Luminaire Schedule							
Symbol	Qty	Label	Arrangement	LMF	Lum. Lumens	Lum. Watts	Part Number
	8	T1	SINGLE	1.000	N.A.	30	RS-30WLED-DO-xx-120
	1	SF2b	BACK-BACK	1.000	17291	130	OSQ-A-NM-4ME-K-57K-UL-xx
	3	SF1	SINGLE	1.000	17291	130	OSQ-A-NM-4ME-K-57K-UL-xx
	20	LFL8	LFL 8FT	1.000	N.A.	70	LFL-A-8-DO-UL-SV-53K-SA
	2	LFL4	SINGLE	1.000	N.A.	35	LFL-A-4-DO-UL-SV-53K-SA
	2	F10	WALL MOUNT	1.000	2490	19	XSPW-B-WM-3ME-2L-57K-UL-BZ
	4	F1	SINGLE	1.000	4584	66	FLD-OL-SN-D2-14-E-UL-SV-700

Calculation Summary (Footcandles calculated using initial lumens @25°C)						
Label	Units	Avg	Max	Min	Avg/Min	Max/Min
Property Line	Fc	0.00	0.0	0.0	N.A.	N.A.
Pavement	Fc	4.43	25.9	0.0	N.A.	N.A.
Off Pavement	Fc	0.50	6.7	0.0	N.A.	N.A.

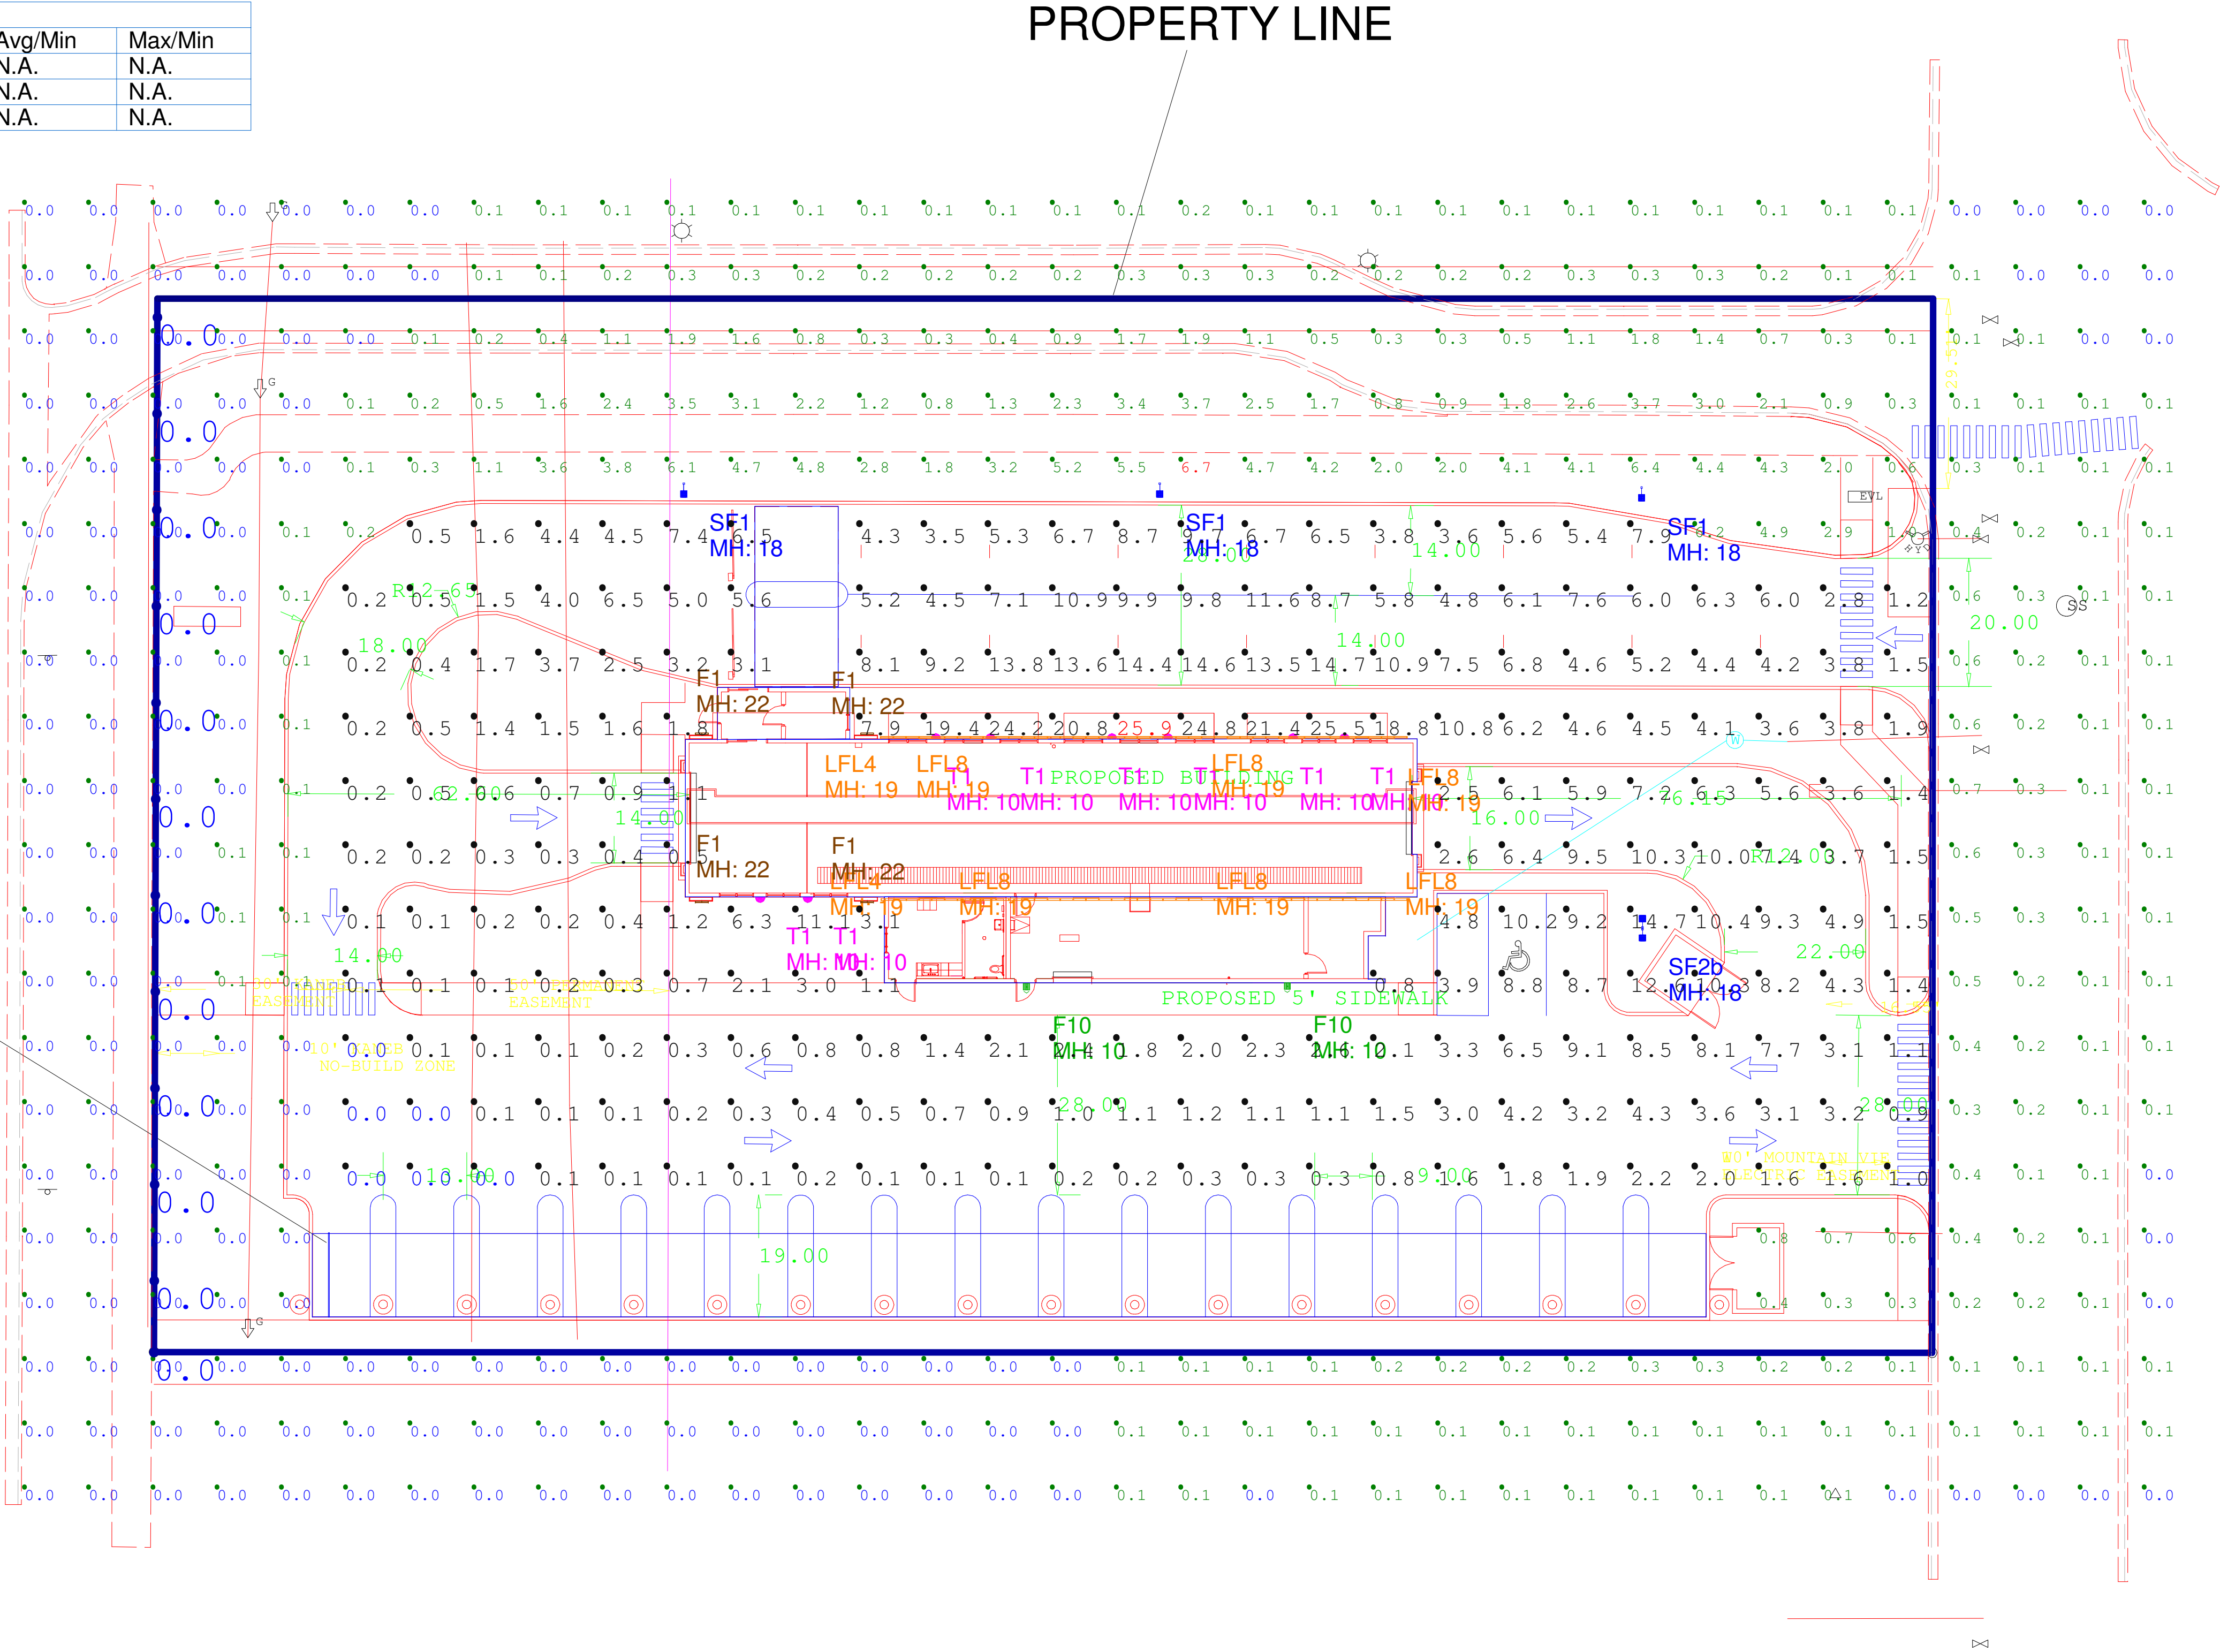
Canopy lights are not shown on the layout.

Canopy lights are downward facing and should not be cause of glare due to angle and degree of canopy sloping.

Section 6.2.3(B)(1)(d)
Maximum Levels, on-site lighting shall not exceed 10 footcandles throughout the site.

Layout subject to change based on no vacuum stalls allowed in water easement

1' Shield/Baffle 6" away from the fixture to achieve the spill goal.
